Subject: Barnageeragh Landfill - Regulation 7 Notice H0167-01
Attachments: MGE0755LT0002 Response to EPA Queries F01.pdf

Our ref: MGE0755LT0002

RE: H0167-01 - Barnageeragh Landfill – Notice in accordance with Regulation 7(4) of the Waste Management (Certification of Historic Unlicensed Waste Disposal and Recovery Activity) Regulations, 2008

Project	BARNAGEERAGH HISTORIC LANDFILL TIER 2 AND TIER 3
Title	BARNAGEERAGH HISTORICAL LANDFILL SITE LOCATION MAP
File Identifier	MGE0755-RPS-00-XX-DR-C-DG0001-01
Status	S0
Rev	F01

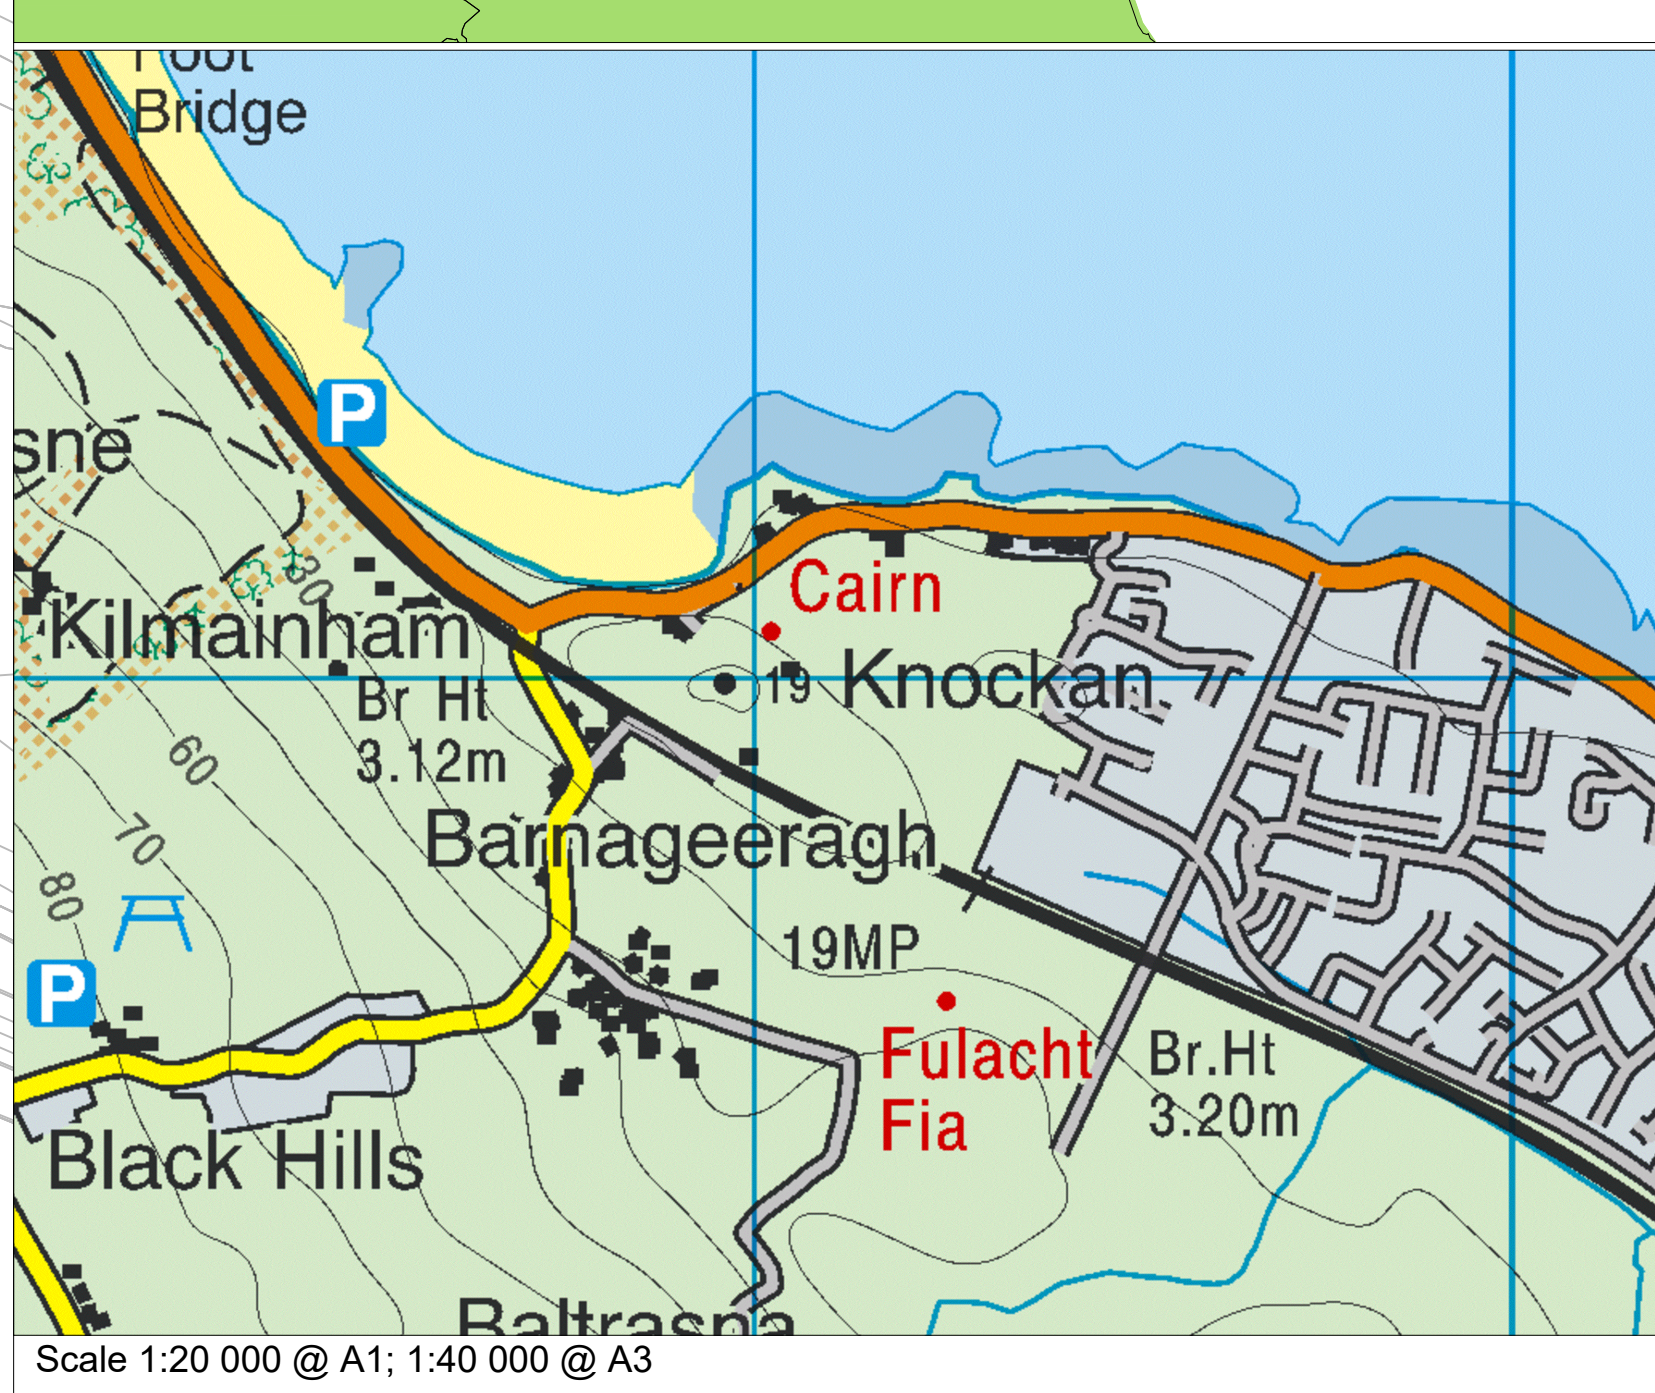
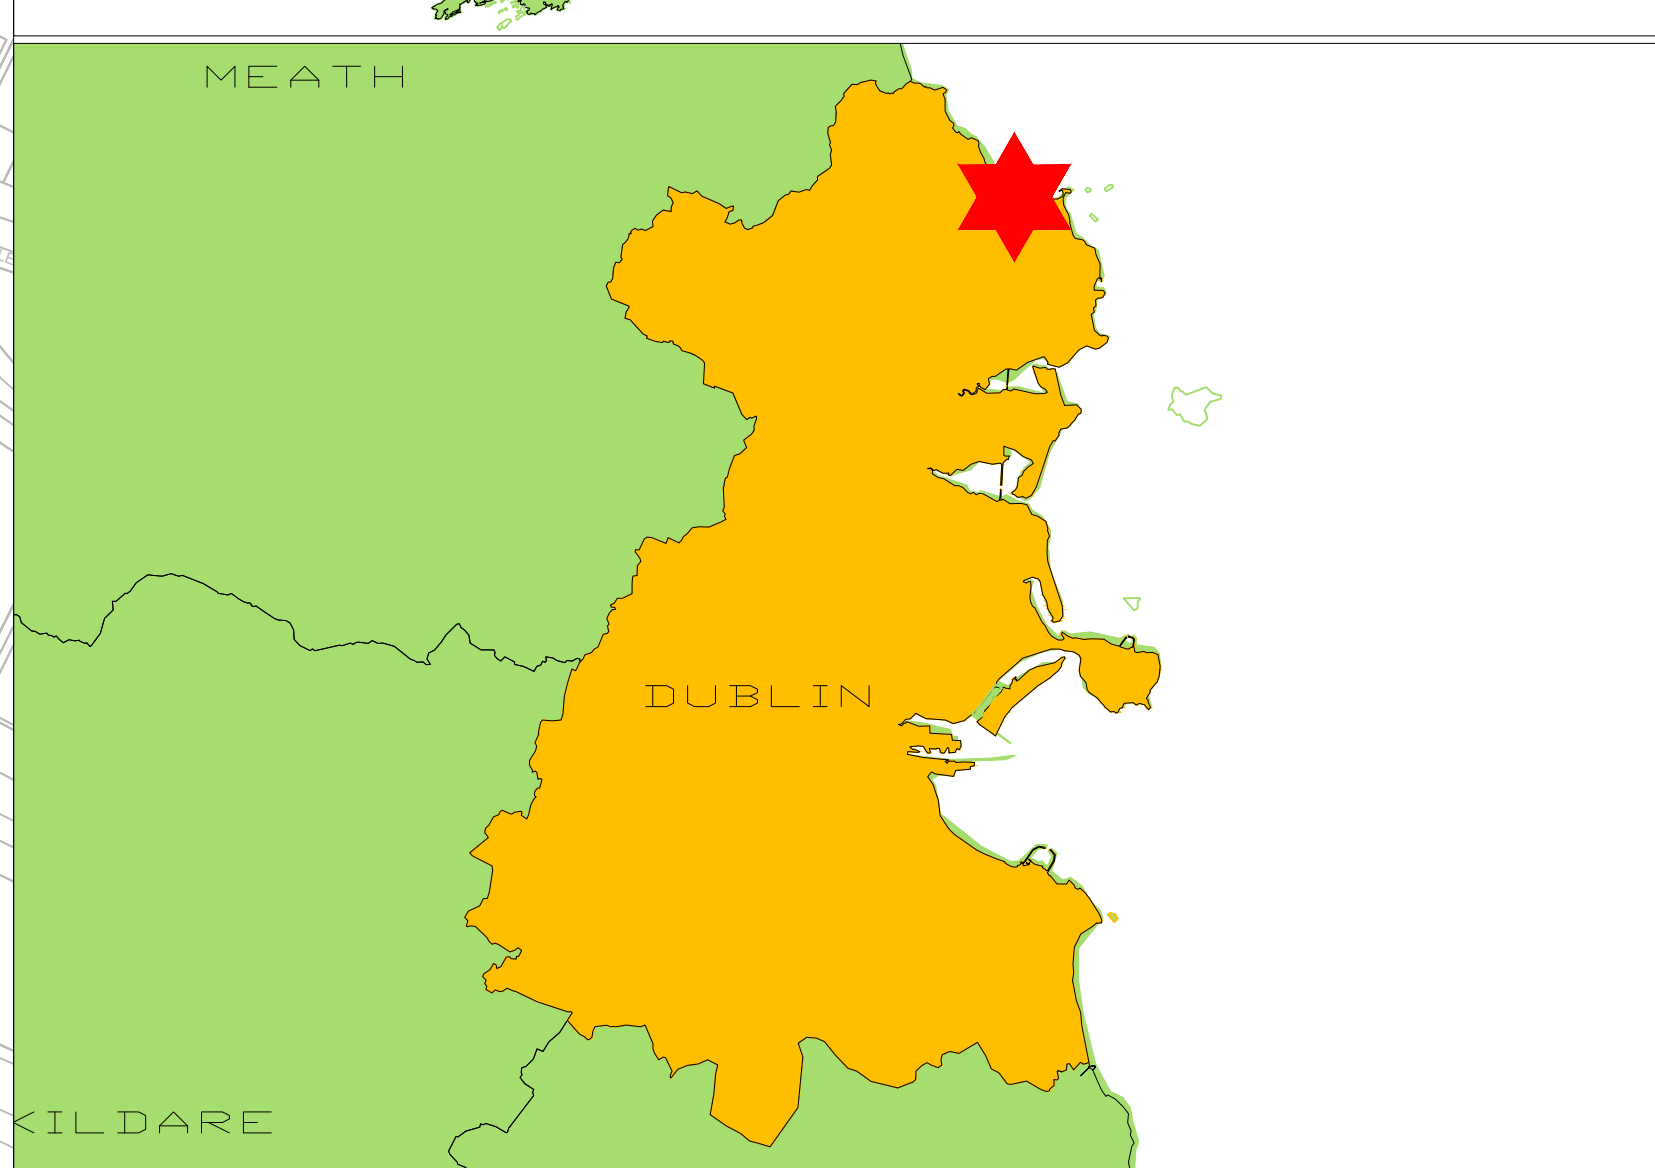
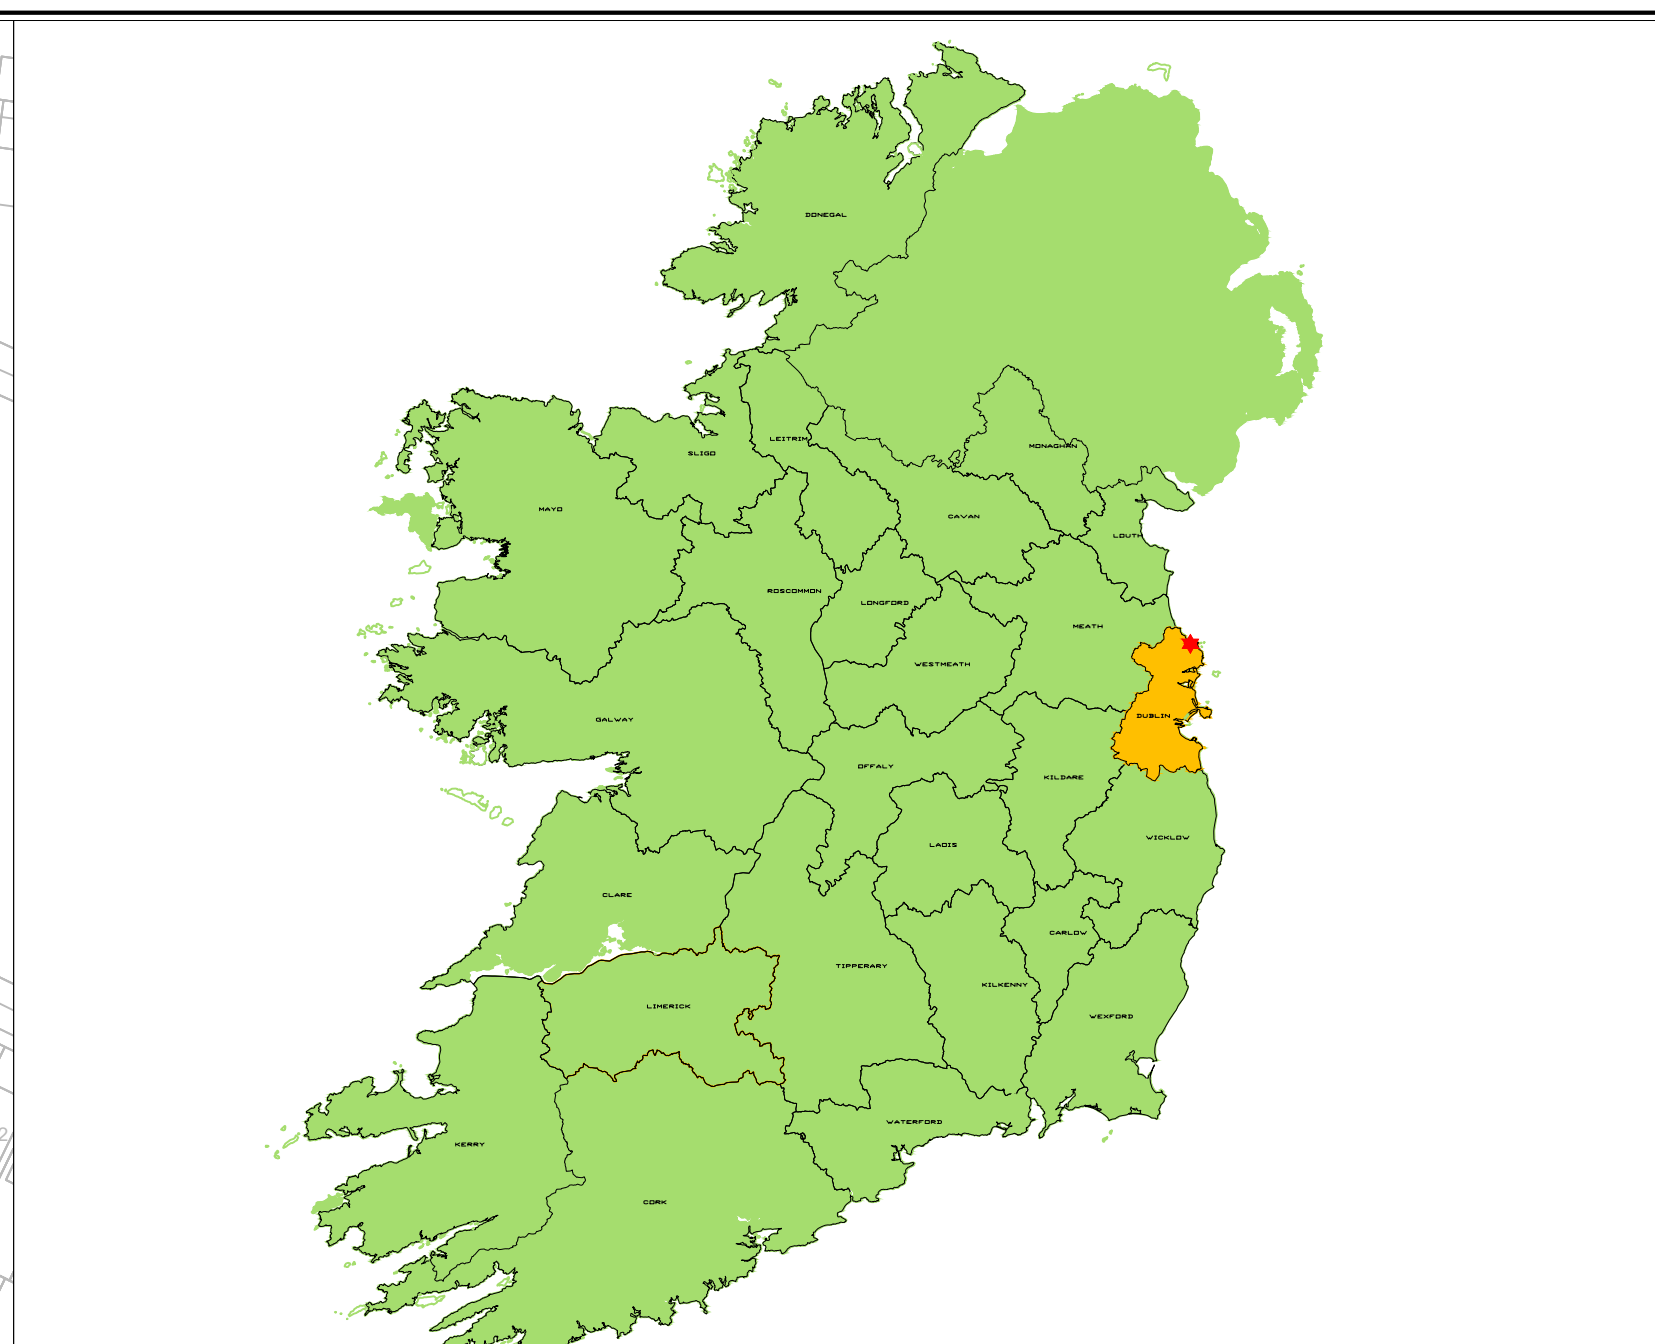
The attached updated drawing MGE0755-RPS-00-XX-DR-C-DG0001-01 is the correct drawing alongside drawing and MGE0755-RPS-00-XX-DR-C-DG0001-02. These drawings have been updated to incorporate a site survey completed by the developer in October 2020. The drawings show the site boundary, interpreted waste boundary and the line of the LL/DPE capping. Section 1.2 of the non-technical summary has been updated to reflect this.

(d) The site boundary on the drawings have been updated to include TP43.
